UNITED STATES PATENT AND TRADEMARK OFFICE

APPLICATION NO.	FILING DATE	FIRST NAMED INVENTOR	ATTORNEY DOCKET NO.	CONFIRMATION NO.
09/989,271	11/20/2001	Michael C. Smyk	FCI-2632/C3069	9590

Office Action Summary

DETAILED ACTION

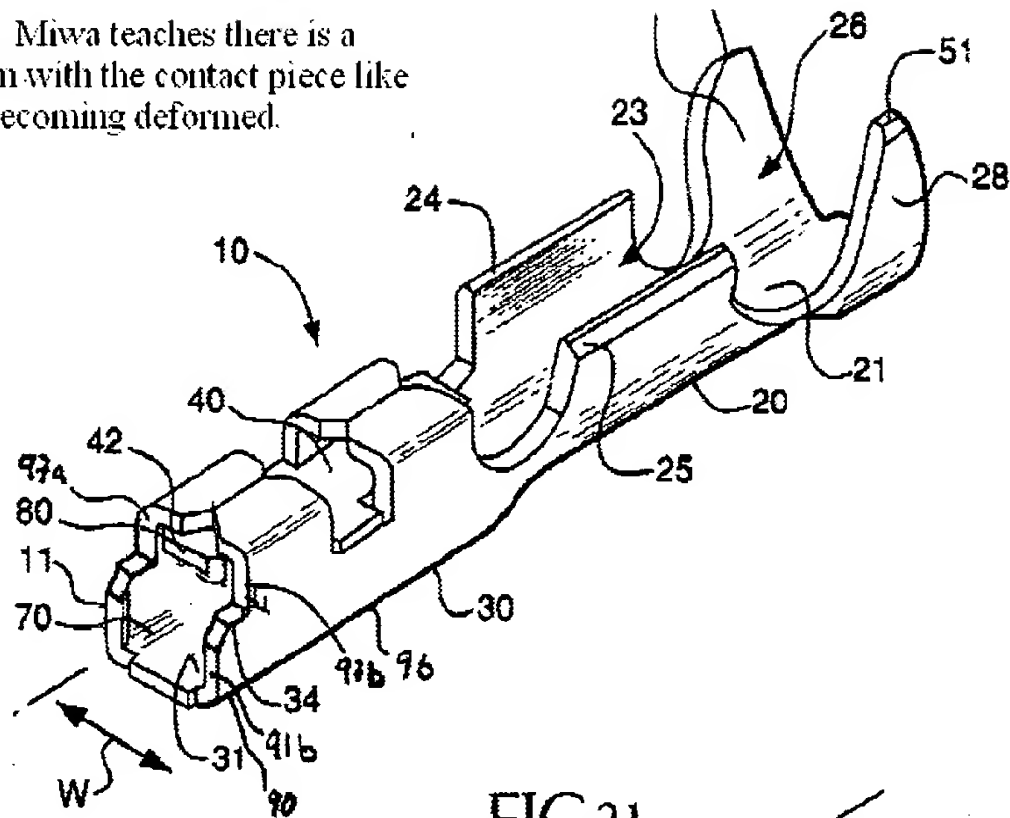
-- In reference to claims 20-42, FCI's Jumbo PV Receptacle shows substantially the invention as claimed. However, FCI's Jumbo PV Receptacle does not show a protecting wall portion.

Miwa shows a protecting wall portion 51.

It would have been obvious to one of ordinary skill in the art at the time the invention was made to protect the bent portion of FCI's Jumbo PV Receptacle with the protecting wall portion of Miwa (see examiner's figures) because, as taught by Miwa, the resilient contact piece needs protected before it is placed into the housing (column 1, lines 40-50).

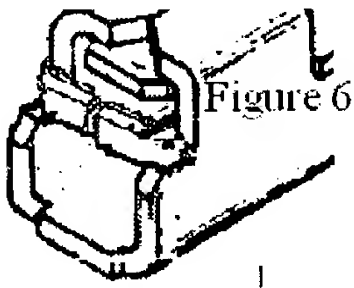
-- In response to applicant's argument (page 6, lines 5-6) concerning that FCI's jumbo PV Receptacle does not show claim 30's limitations and that Miwa does not show claim 30's limitations, the argument is not convincing. 37 CFR § 1.111(b) states, "A general allegation that the claims define a patentable invention without specifically pointing out how the language of the claims patentably distinguishes them from the references does not comply with the requirements of this section." Applicant has failed to specifically point out how the language of the claims patentably distinguishes them from the references because substantially every element number pertaining to claim 31 is shown in Step 1 and the associated examiner's figure.

Although applicant did not claim the protection wall (substantially equivalent to Miwa protection wall 51 (see the examiner's figure associated with Step 2 of the rejection)) FCI's jumbo PV Receptacle as modified by Miwa also shows the same protection wall and resulting structure.
